Legistar I.D. #16006

1246-1252 Williamson St. & 308-310 S. Baldwin St.

Demolition and Rezoning

Related Approvals Update

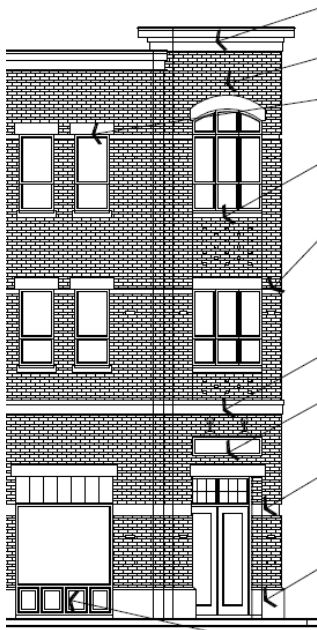
Corner Detail – This morning, after a meeting with Marquette Neighborhood Association (MNA) representatives, the applicant proposed an additional change to the treatment of the third floor window on the corner element. This change is contrary to Condition No. 12 in the staff report, which was based on a recommendation by the UDC in their Final Approval.

The arched window with no canopy as shown in **Version A** below was recommended by the Urban Design Commission for Final Approval. Staff understands that the canopy over a window with no arch, as shown in **Version B**, is preferred by MNA representatives.

The Landmarks Commission expressed in their motion that they would grant certificates of appropriateness for either version, with a strong preference for **Version B.**

The Planning Division staff recommendation for approval remains the same, regardless of the treatment of this design detail. Staff recommends that the Plan Commission consider input received on the design and make any appropriate revisions to Condition No. 12 in their recommendation to the Common Council.
